RFB FOR CURRITUCK COMMUNITY PARK PHASE III- BASEBALL/SOFTBALL FIELDS

Date: December 23, 2025

Subject: Addendum No. 1 to RFB for Currituck Community Park Phase III- Baseball/Softball Fields

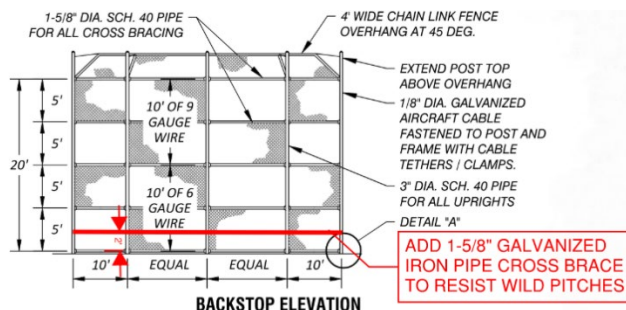
1. Could you please advise if the dimensions of the Dugouts should be based on the specification or what is shown on the drawings? Specification says to refer to drawings. Please advise. The spec also states to match the existing roof slopes on campus of 2:12 but the drawings show a 4:12 roof pitch. Which roof pitch should we use?

Response: *Dugout dimensions should be based on what is shown on the drawings (column locations identified on architectural sheets) and coordinated with the foundation plans (as shown on structural drawings). Roof pitch of prefabricated structures should match other existing similar structures on the campus, contractor to field verify.*
